HISTORIC AND DESIGN REVIEW COMMISSION

September 04, 2024

HDRC CASE NO: 2024-267
ADDRESS: 2619 MCCULLOUGH AVE
LEGAL DESCRIPTION: NCB 1704 BLK 12 LOT N1-2 OF 12 & 13
ZONING: O-1, H
CITY COUNCIL DIST.: 1
DISTRICT: Monte Vista Historic District
APPLICANT: Matthew Gilbert/Ortiz McKnight PLLC
OWNER: ZUNIGA LAW PLLC
TYPE OF WORK: Requesting a waiver, fenestration modifications
APPLICATION RECEIVED: July 19, 2024
60-DAY REVIEW: September 17, 2024
CASE MANAGER: Claudia Espinosa

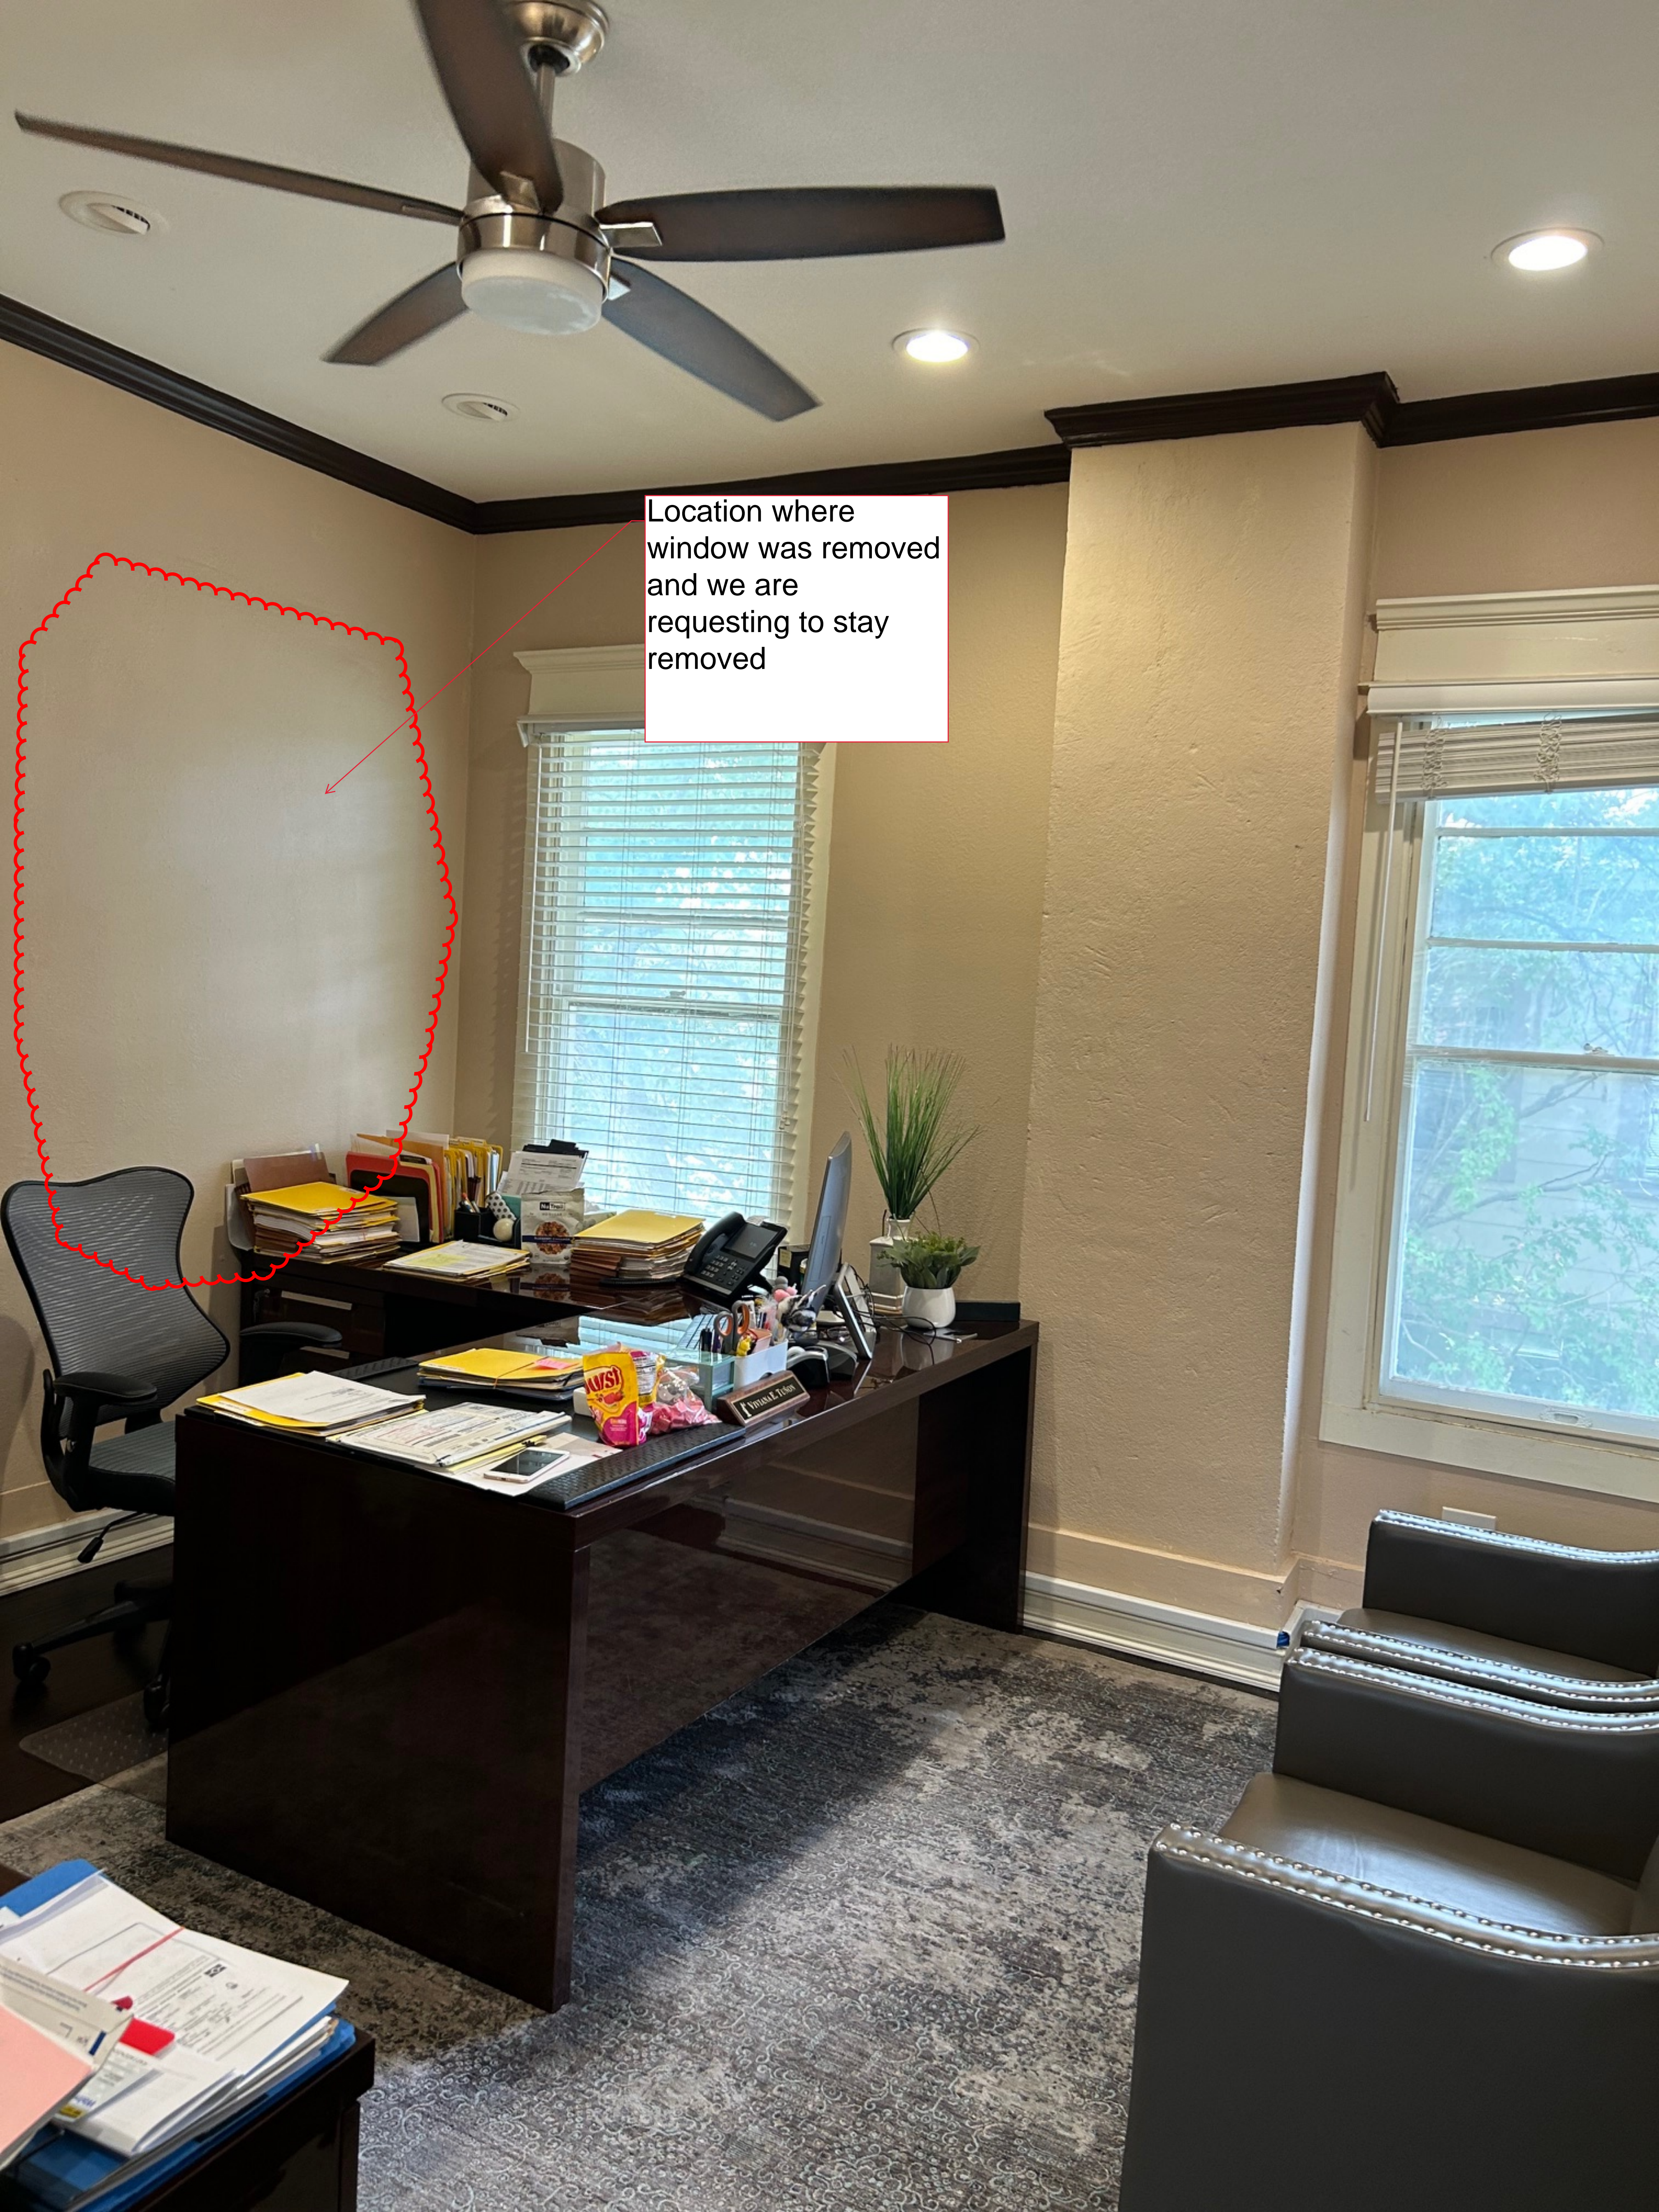
Location of
request to
have siding
remain

Location of 3
re-built
wooden
windows

Locations of
2 of the
requested
new wooden
screens

Location of 3
re-built
wooden
windows

Location of remaining 3 windows requested for new wooden screens

Location where
window was removed
and we are
requesting to stay
removed

EXHIBIT

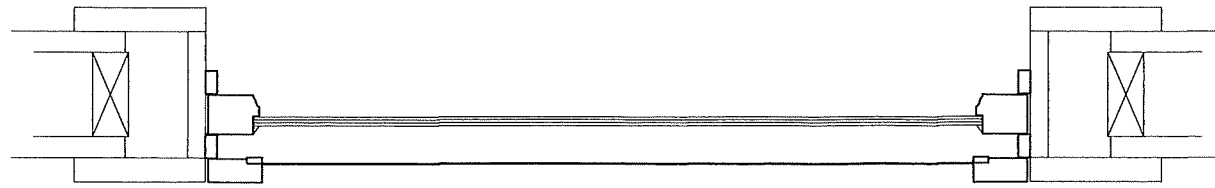
NEW WOOD CASEMENT WINDOW. SIZE, PROFILE, AND CONFIGURATION
CONSISTENT WITH ORIGINAL CONSTRUCTION. PUTTY GLAZED WITH
1/8" CLEAR ANNEALED GLASS.MADE FROM SPANISH CEDAR.

EXHIBIT
5

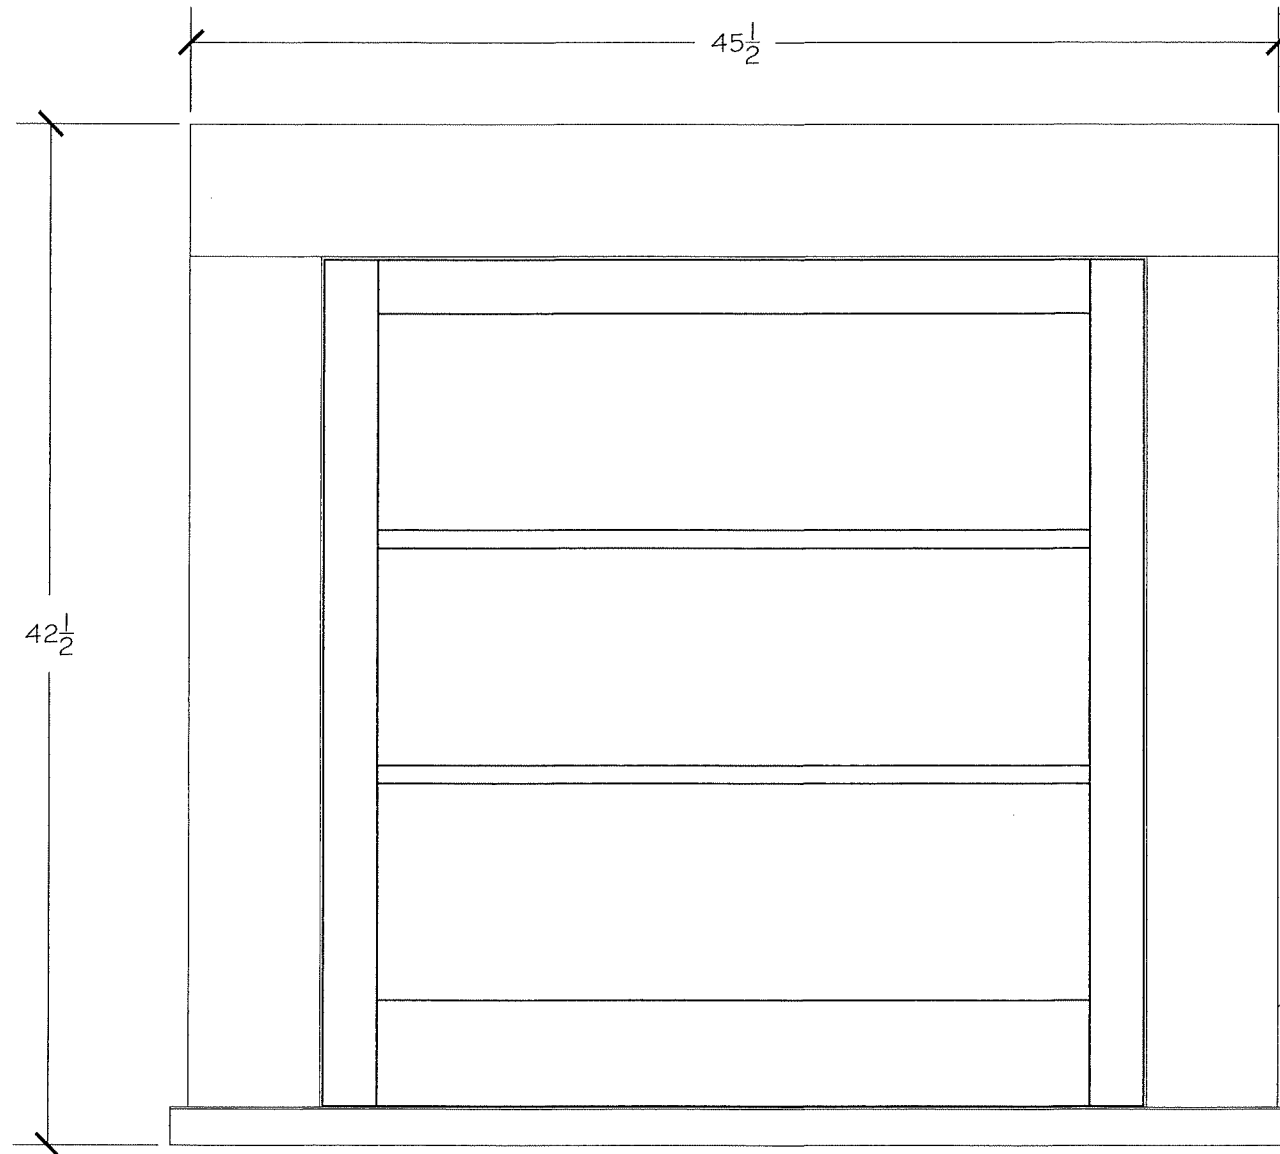
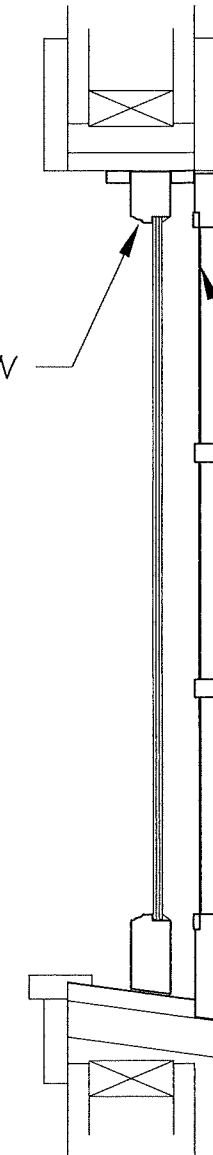
- d. **WINDOW OPENING MODIFICATION (SOUTH FACADE)** – The applicant has proposed to replace five (5) window openings on the south facade and shorten the overall size of two of the openings. As a revision to the original proposal, the applicant has proposed to install wood window screens onto the replacement windows. The Guidelines for Exterior Maintenance and Alterations 6.A.i. notes that historic window and door openings should be preserved and discourage the modification of window sizes. It is unclear if the windows at this location were original prior to their removal; sash windows were likely the original condition on this facade. Similar, smaller sashed windows are located on the north facade and may be used as a reference. Staff finds that modifications to these openings are generally appropriate provided that any replacement windows are consistent with the Guidelines. The installed fixed windows are not consistent with the Guidelines. The applicant has proposed wood screens to disguise their appearance.

- i. Approval to retain the five altered window openings on the south face with the stipulation that appropriate one over one sash windows are installed instead of a fixed window based on finding d. The proposed window screens are appropriate and may be installed regardless of commission disposition regarding the window product. If the HDRC approves retention of the fixed windows, then staff recommends the window screens be required.
- ii. Staff does not recommend approval of the window infill east elevation based on finding e. Staff recommends that the applicant restore the window opening with a salvaged window or replacement product that matches in size, operation, design, and configuration.
